**SUBJECT: Rqpvkce'Ncnxlg' Cr ctwo gpw'(Preliminary Site Plan)**

**RE: Pontiac Lake Overlook (FKA Pontiac Lakeview Apartments)- Preliminary Site Plan Review – 4<sup>th</sup> Review**

**Subject:** Pontiac Lakeview Apartments Preliminary Site Plan Review #4  
Tax Parcel No. 12-13-328-001

**Existing Conditions Plan**  
"Pontiac Lake Overlook"  
PART OF THE SW 1/4 OF SECTION 13, T.3N., R.8E., WHITE LAKE TOWNSHIP, OAKLAND COUNTY, MICHIGAN

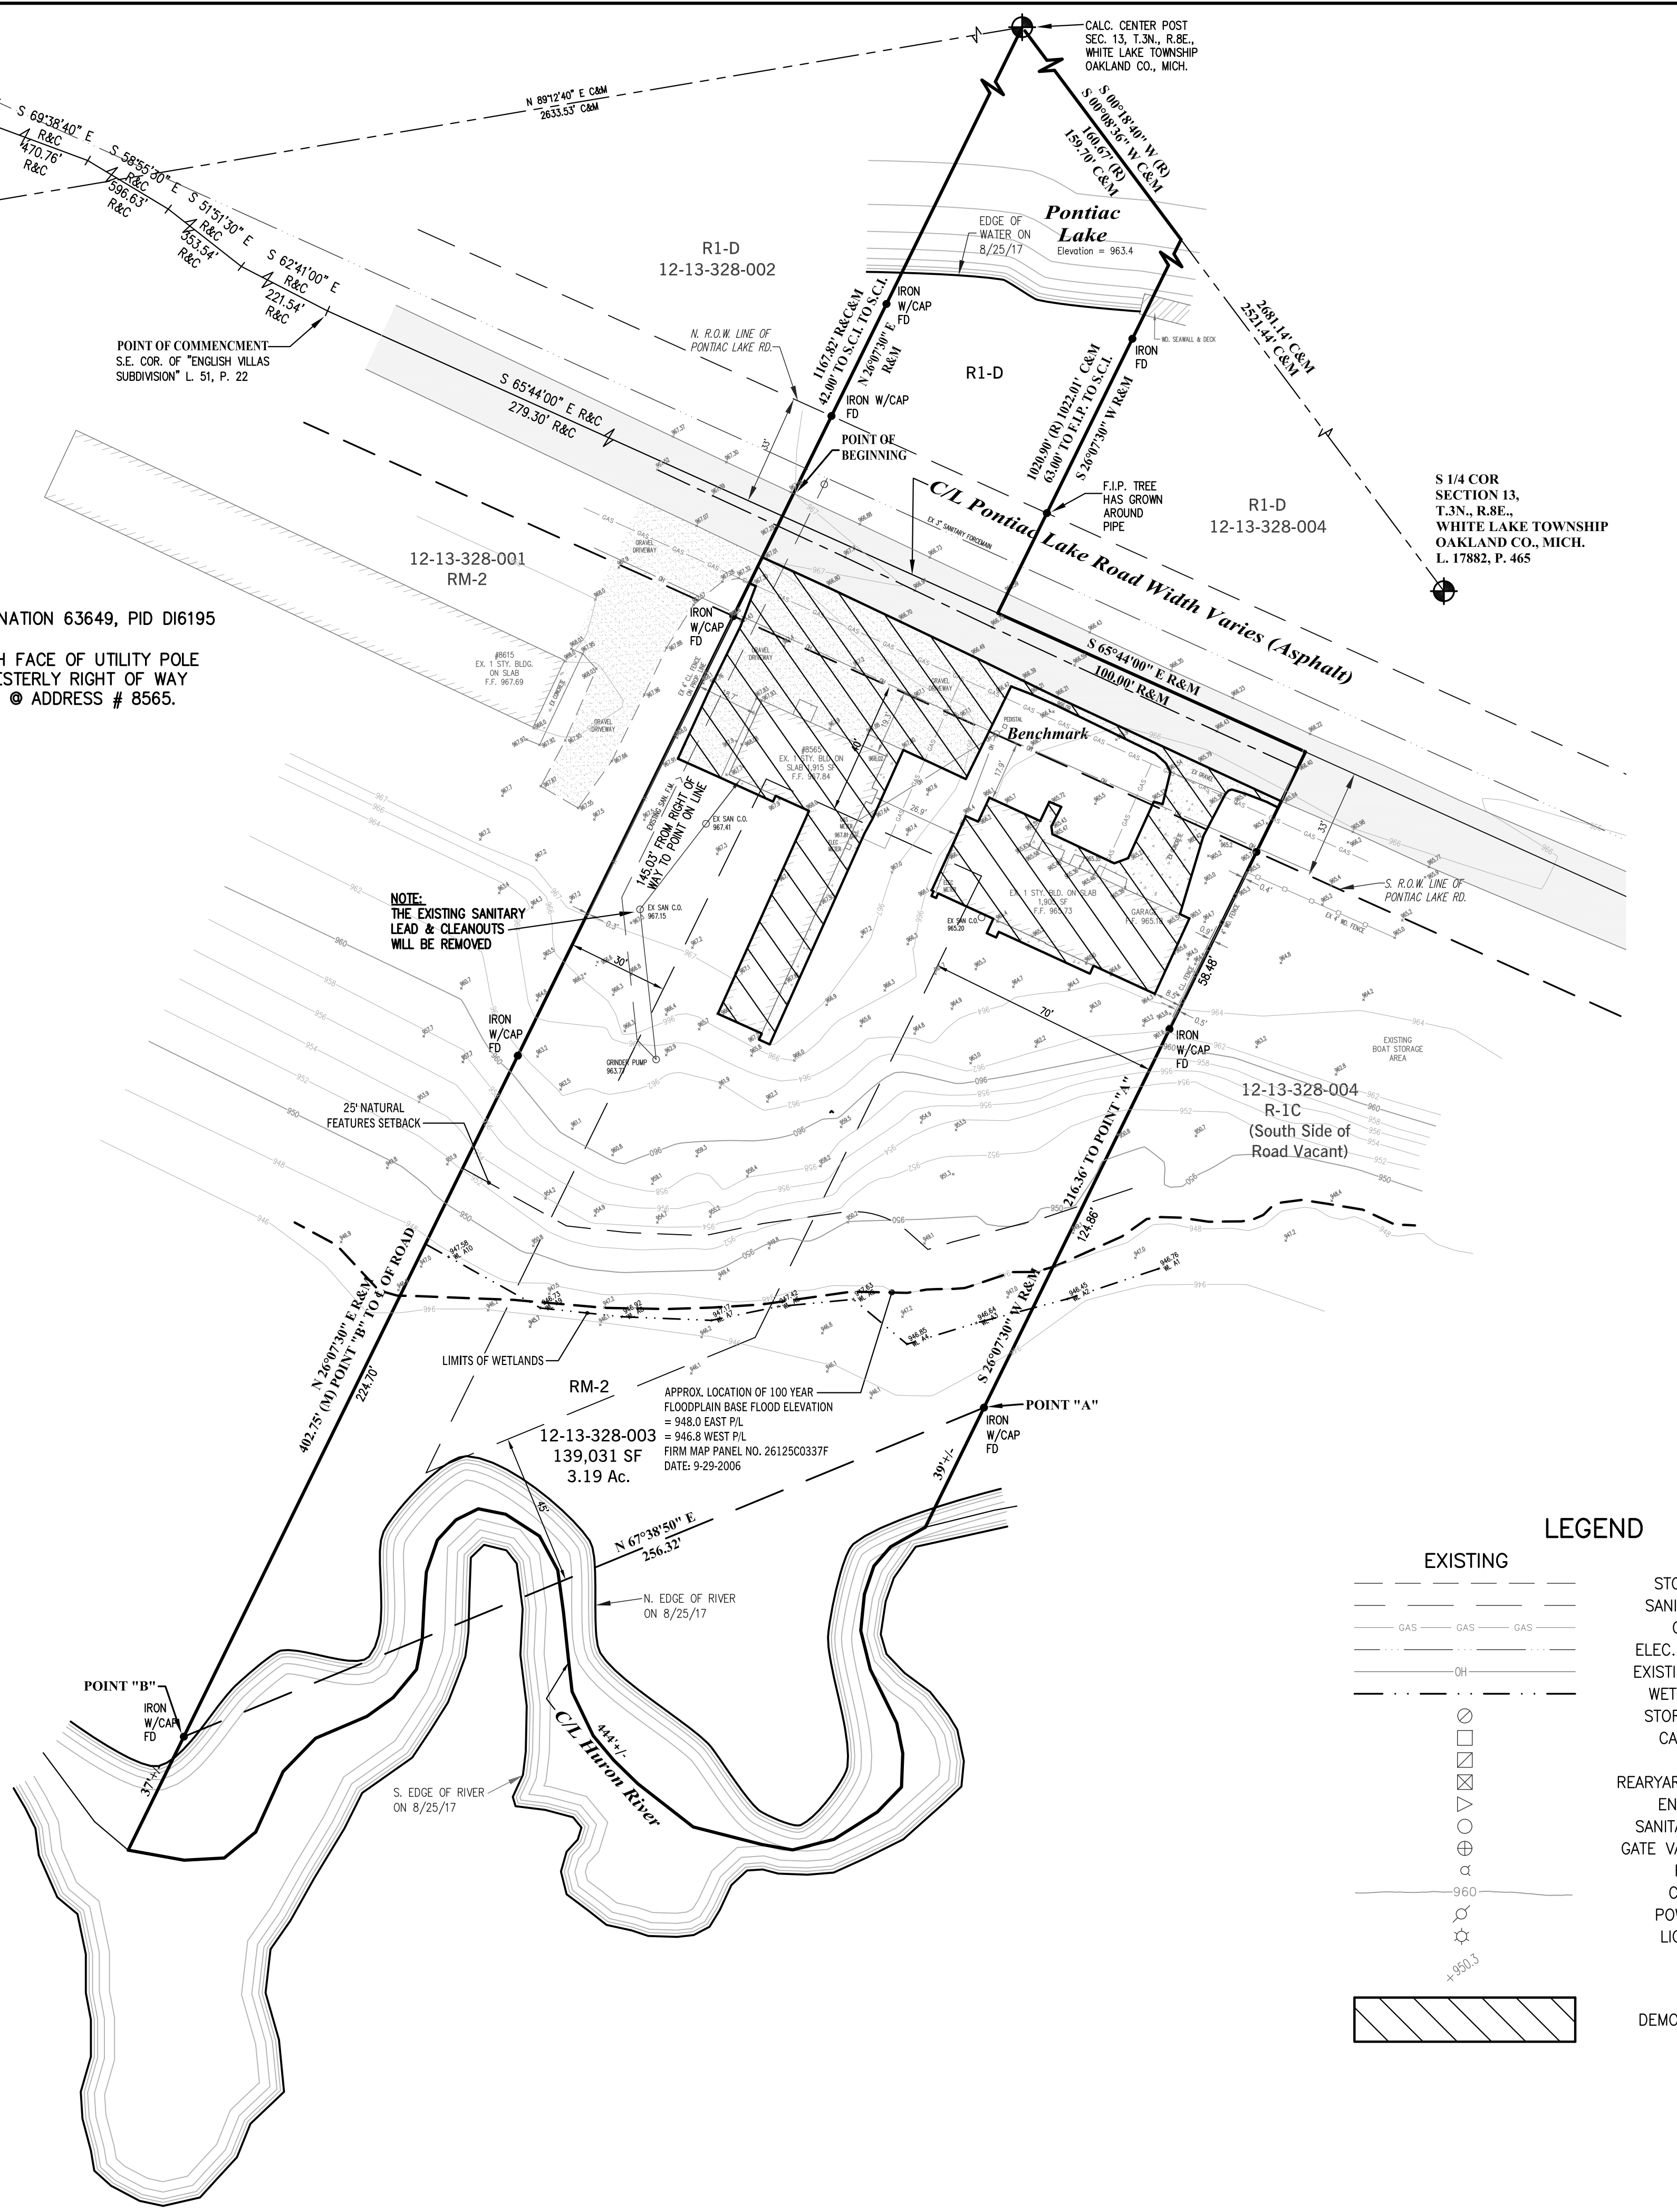
1. *The plans have been sealed by a Licensed Professional Engineer. However, a signature on the seal has not been provided and is required.* **Comment outstanding. A signature in addition to the engineer's seal is required. The design engineer has indicated in their response letter that a signature has been added to their seal on Sheet 1. We are unable to locate signature on the electronic submittal.**

2. *Indicate if there are any wetlands on site and delineate wetland boundaries. A permit from the MDEQ may be required. Comment partially addressed. Wetlands and their delineation have now been shown on the plan. Comment remains as a notation with regard to a permit from the MDEQ that may be required.* **Comment remains as a notation. Design engineer has indicated a permit from EGLE will be obtained for storm discharge.**

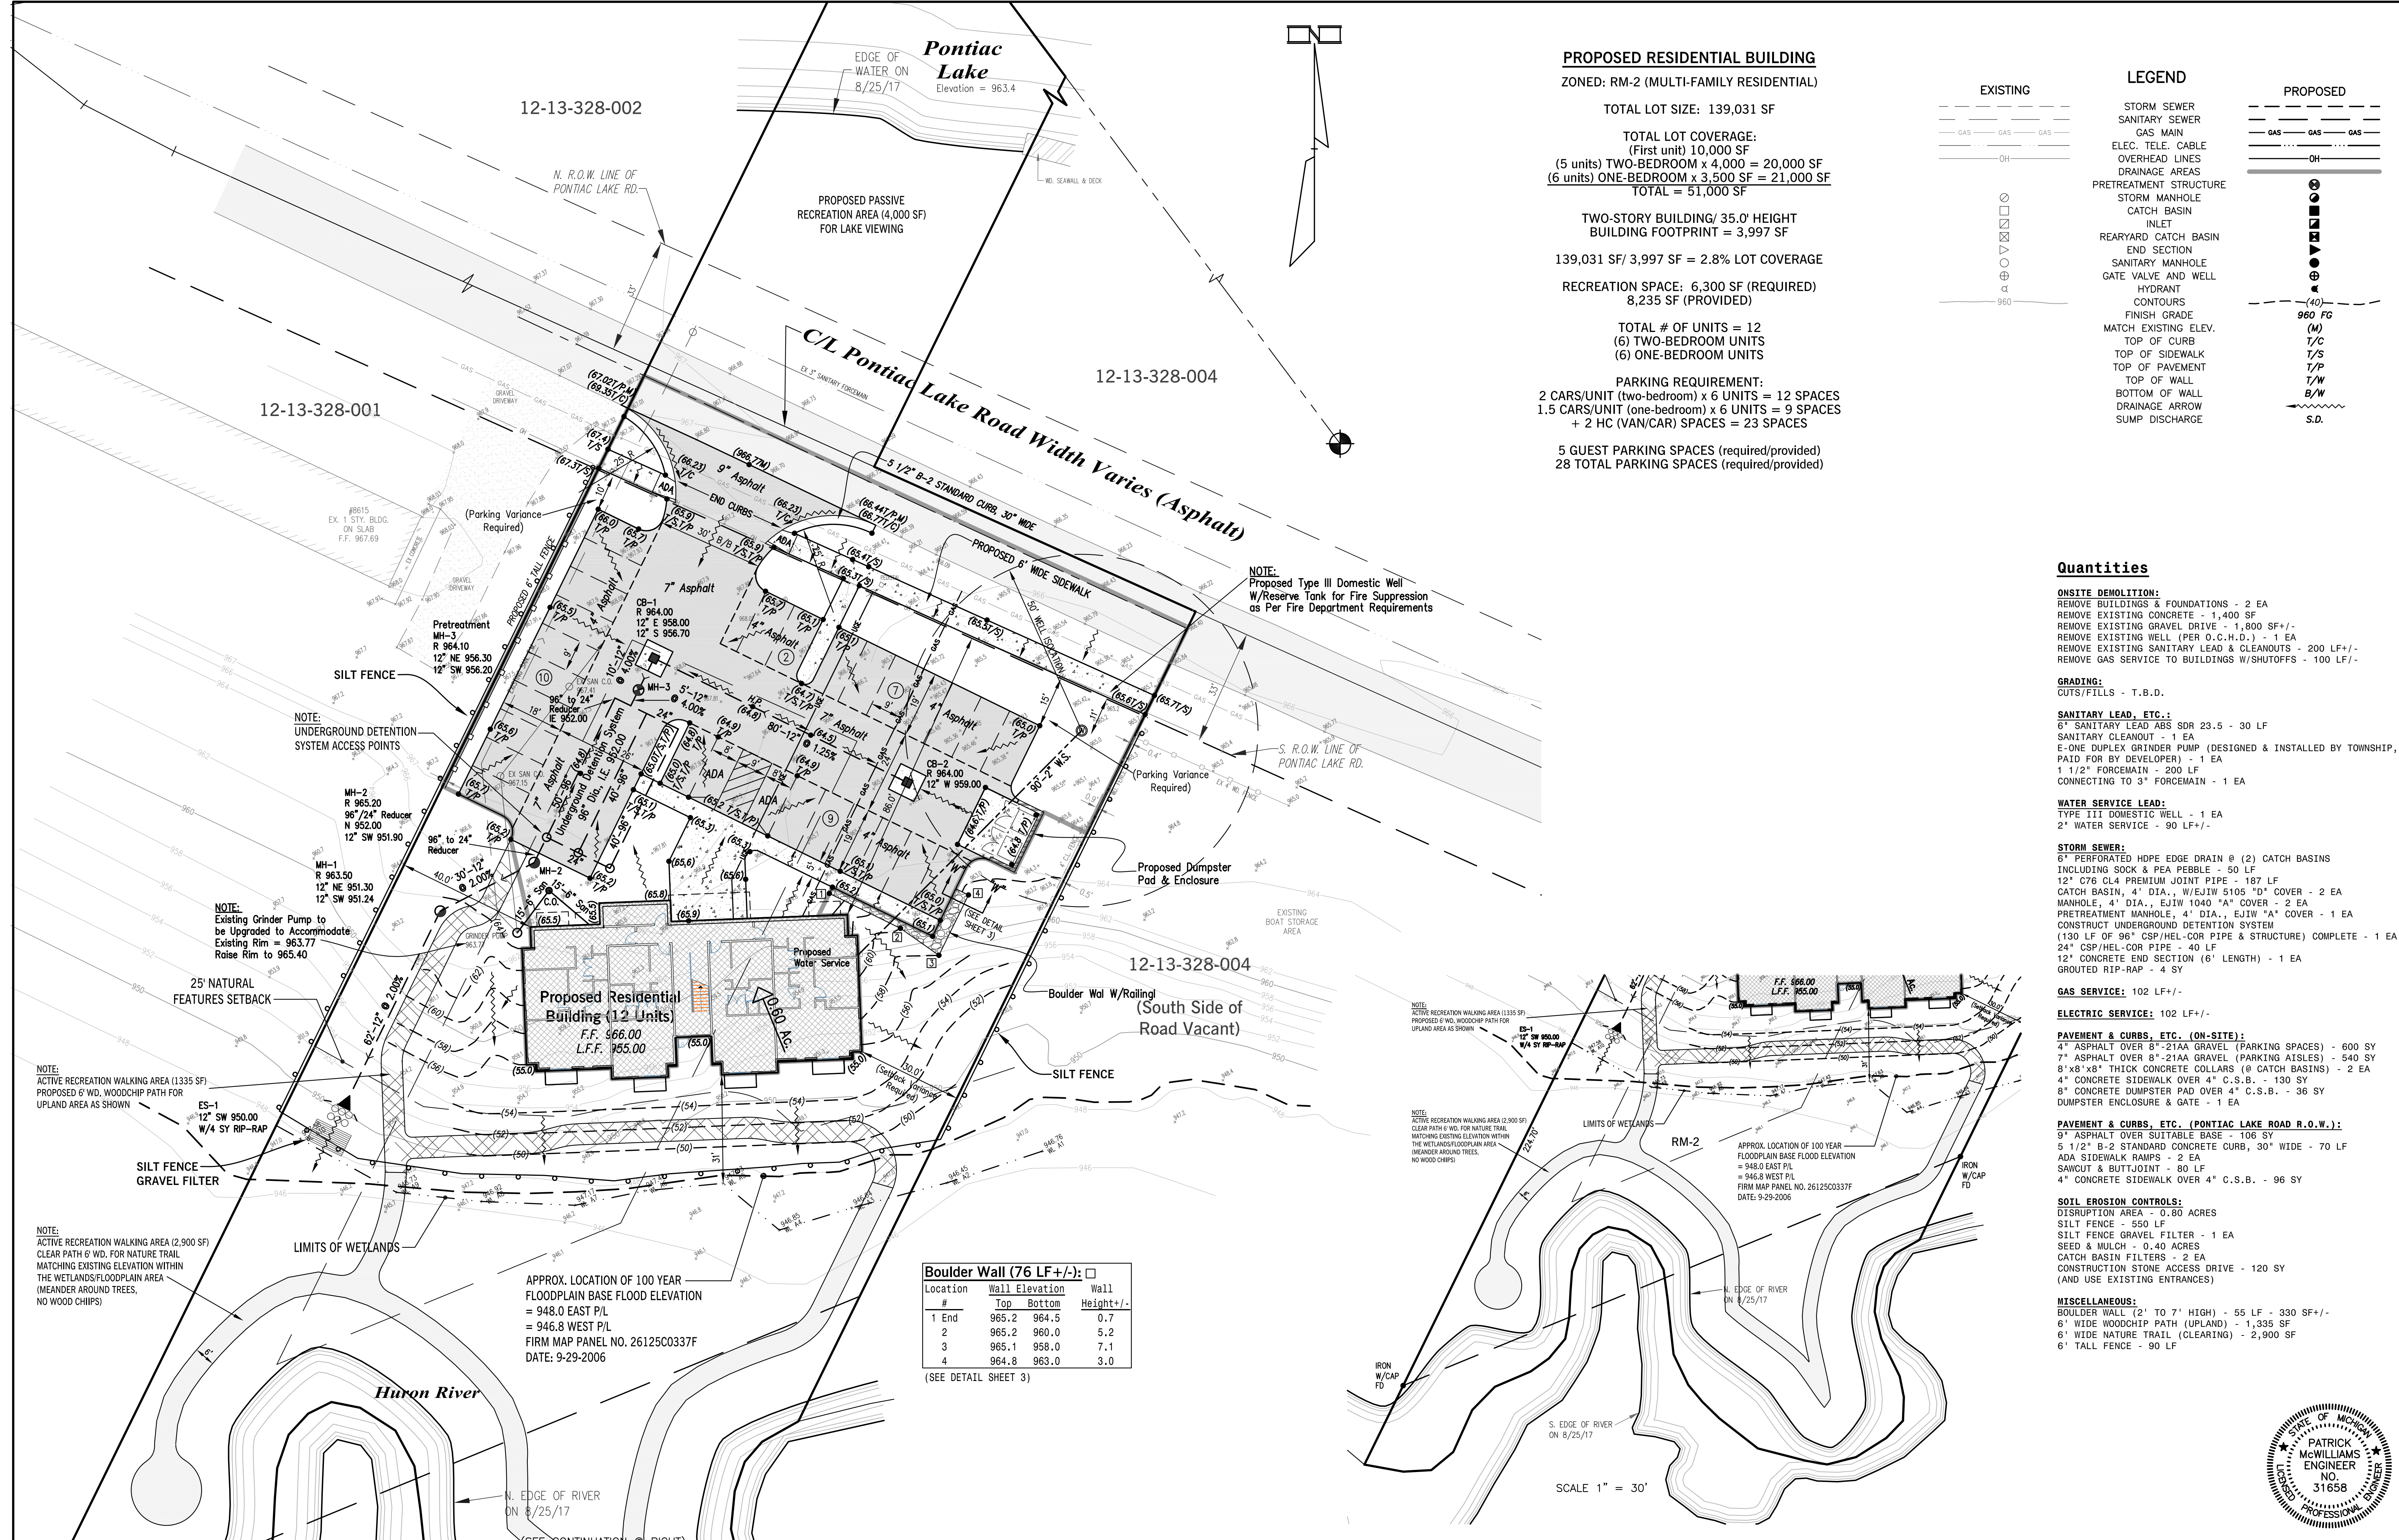
3. *It appears that a portion of the proposed building is within the 25' Natural Features Setback. The balcony scales approximately 17 feet from the wetland line at its closest point. We defer to the Township regarding which features of the proposed facility count towards the setback requirement.* **Comment addressed, the plan has been updated and provides the minimum setback or greater, even to the balconies.**

3. *Additional details regarding the proposed retaining wall will be required at time of FSP/FEP submittal. The impact of the wall footings on the proposed storm outlet and the proposed depth of the storm outlet will need to be addressed. Additionally, a railing will need to be provided for all wall sections that are greater than 30" in height. The proposed wall is no longer in proximity to the proposed storm outlet so above comment regarding this is no longer a concern. Comment remains regarding requirement for a railing.* **Comment addressed. Design engineer has indicated on plans that a railing will be provided at top of wall. A more detailed review of the railing in terms of height required will be done at time of Final Engineering Plan submittal.**

4. Comments were made at the January 18, 2021 Planning Commission Meeting regarding the lack of curbing on the proposed site. We offer the following in regard to curbing required by the Township Ordinance:

Finally, details for a proposed eight-foot poured concrete trash enclosure with a lockable metal gate are provided on sheet three of the site plan submittal. The applicant has proposed a poured concrete wall to screen the trash enclosure on three sides, with a metal gate on the fourth. In item two of this review, we noted deficiencies with the proposed location for the enclosure, which will require a variance.

We recommend approval of the Preliminary Site Plan subject to any remaining comments being addressed on the Final Engineering Plan and inclusion of any required curbing as referenced in Grading/Paving #4 above, or successful variance from the requirement.
